ENGINE - STAGE 1 TURBINE NOZZLE ASSEMBLY - PROVIDE NEW FIRST STAGE HPT DUCT SEGMENTS
AND DUCT STOPS WITH BOLT HOLE CHAMFERS - CATEGORY CODE 6 - MOD.ENG-72-0113

V2500-ENG-72-0113

SERVICE BULLETIN

Location of the Stage 1 HPT Duct Segments and Stage 1 HPT Stops For Engines Which Do Not Incorporate V2500-ENG-72-0013

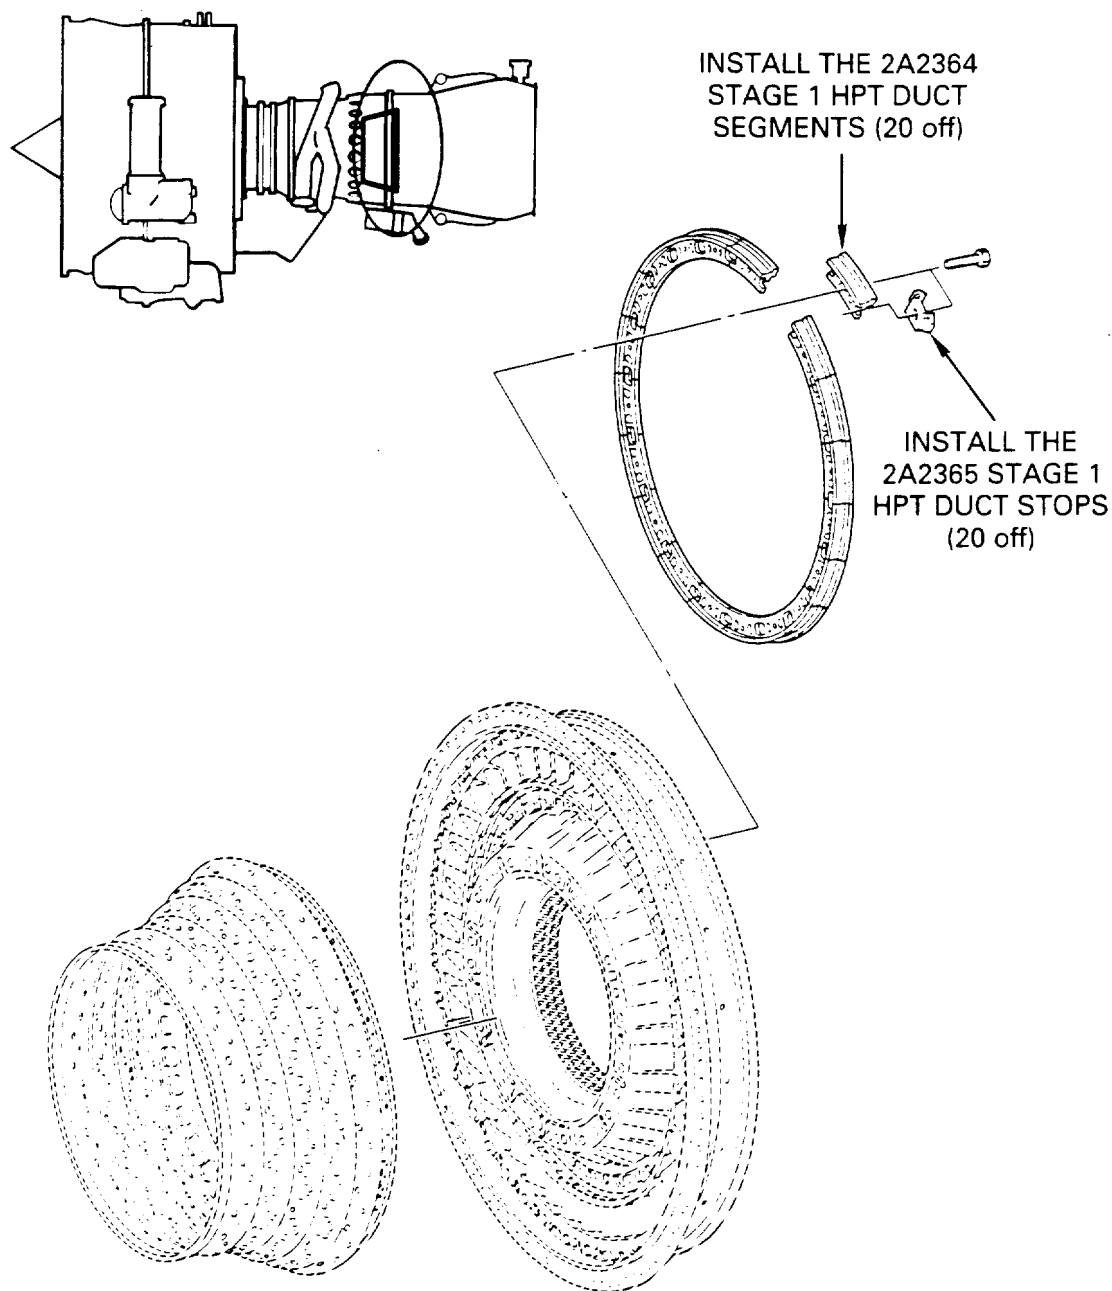
- (1) For engines which do not incorporate Reference (1) install the 2A2363 Stage 1 HPT Duct Segments (20 off) and the 2A2365 Stage 1 HPT Duct Stops (20 off). Use the approved procedure in Reference (3), Chapter/Section 72-44-00, Assembly and Figure 1.
- (2) For engines which incorporate Reference (1) install the 2A2364 Stage 1 HPT Duct Segments (20 off) and the 2A2365 Stage 1 HPT Duct Stops (20 off). Use the approved procedure in Reference (3), Chapter/Section 72-44-00, Assembly and Figure 2.

Modification of the Stage 1 HPT Duct Segments and Stage 1 HPT Duct Stops
Fig.3

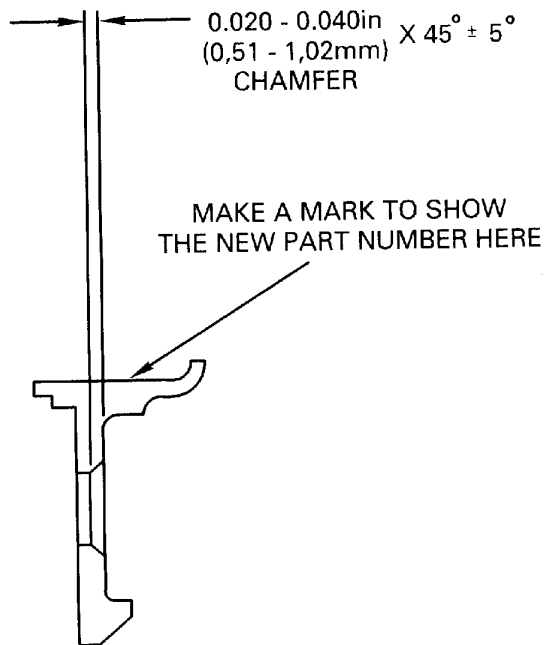
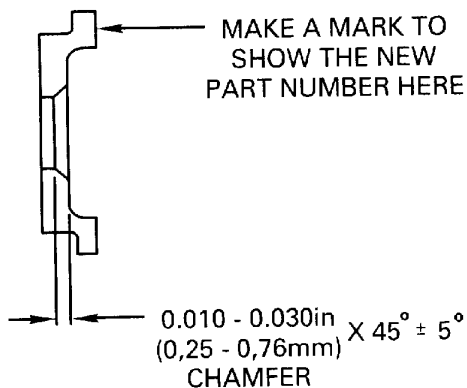
Procedure	Supplementary Information	
(a) Set-up and machine a chamfer at the bolt hole in the stage 1 HPT duct segment (20 off) at the bolt head side.	Refer to Figures 1, 2, and 3, requirements.	
(b) Set-up and machine a chamfer at the bolt hole in the stage 1 HPT duct stop (20 off) at the bolt head side.	Refer to Figures 1, 2, and 3, requirements.	
(c) Make a mark adjacent to the old part number to show the new part number. Use the vibration peen method.	Old Part No.	New Part No.
	2A0087	2A2363
	2A1198	2A2364
	2A0936	2A2365
	Refer to Reference (4), Control No./TASK No. 70-09-00-400-501.

Family tree - Stage 1 HPT Duct Segments
Fig.4

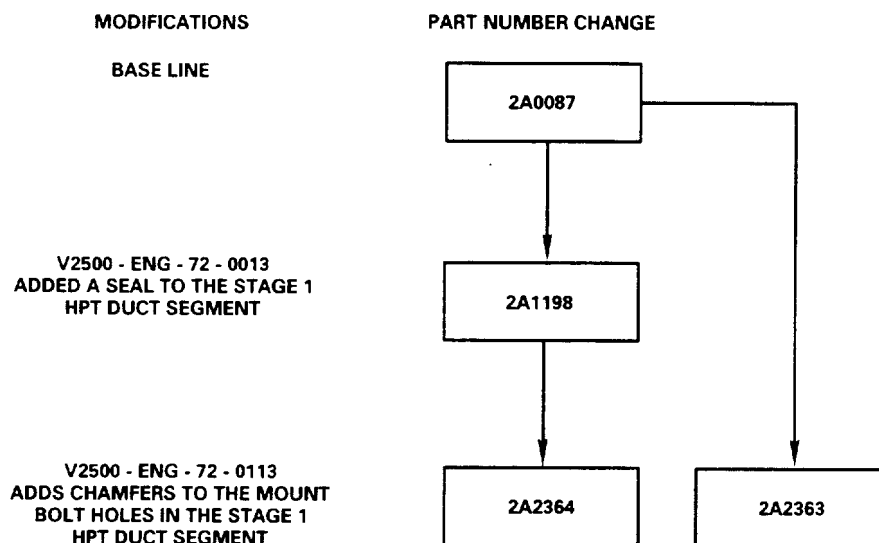
2A2363 (72-44-60)	20	-	Duct Segment, HPT, Stage 1	2A0087 (01-010)	(S1)(1D) (A) (B)
2A2365 (72-44-60)	20	-	Stop, HPT Duct, Stage 1	2A0936 (01-020)	(S1)(1D) (A) (B)

2A2364 (72-44-60)	20	-	Duct Segment, HPT, Stage 1	2A1198 (01-010)	(S2)(1D) (A) (B)
2A2365 (72-44-60)	20	-	Stop, HPT Duct, Stage 1	2A0936 (01-020)	(S2)(1D) (A) (B)
